# MP\_351C-RYSLMT-MOD\_Richland Industries

Reference Document 09-03-2021

351 Compression Riveter

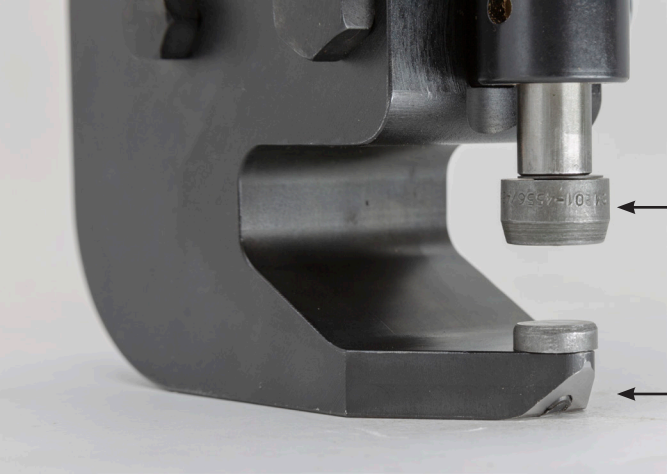
w/ : Roof Top Rail Yoke (modified chamfer on nose)

: Modified P073008-SADJ return piston cap w/ 1/2X20 thread  
Bellville Washer, nut & 1/2X20 adjuster bolt.

Standard adjustable stroke cover removed  
& replaced w/ smooth cover

Will need 2 different upper rivet sets SM200-4556/4568  
SM201-4556/4568

One lower Set SM210  
Spacer SM-50

SM 201-4556/4568

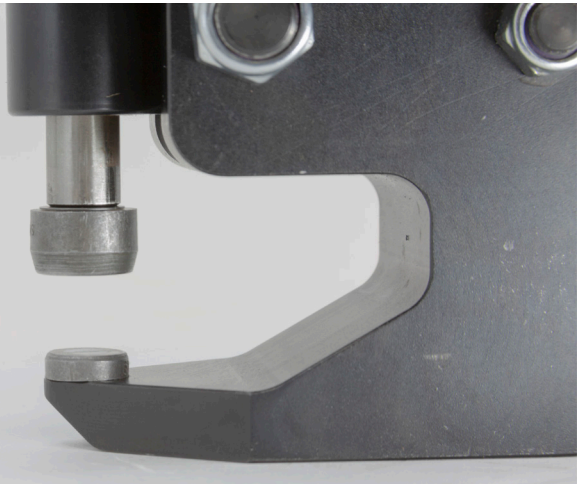
Chamfered Roof Top Rail Yoke

Rivet set holder  
P073237 & rivet set are in forward position  
due to return piston adjuster bolt.

PN: P073008-SADJ  
Stroke adjustable return  
cylinder cap

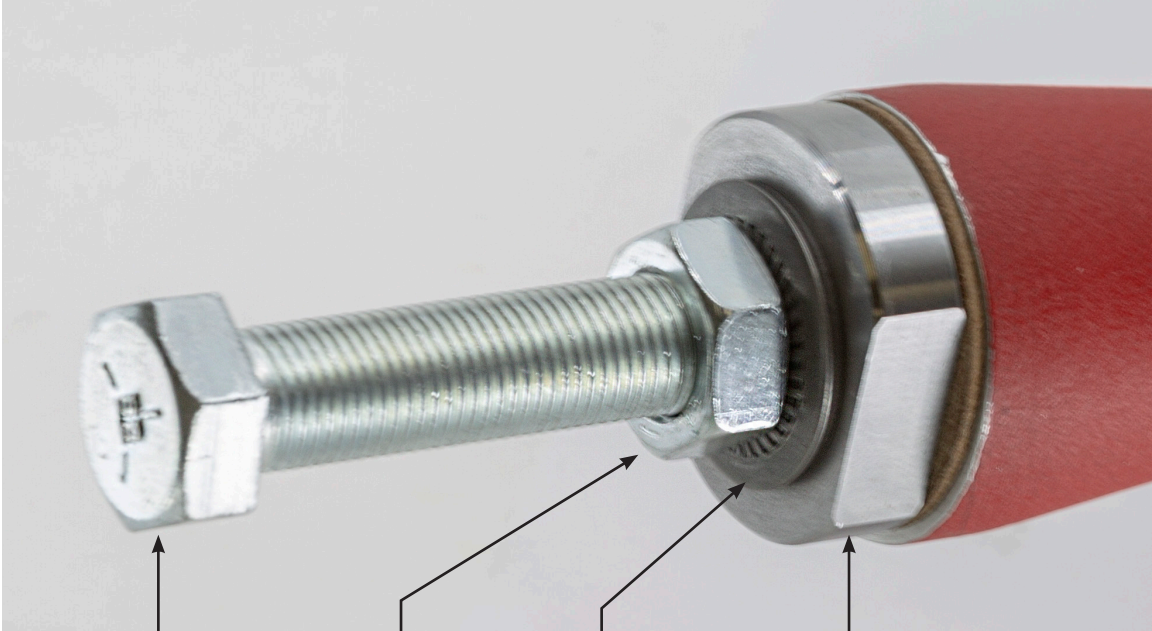
PN: HS-UNF40102G5Z  
Adjuster Bolt

PN: N3-UNF40G5Z  
Lock Nut

PN: BW2-W40  
Bellville Washer
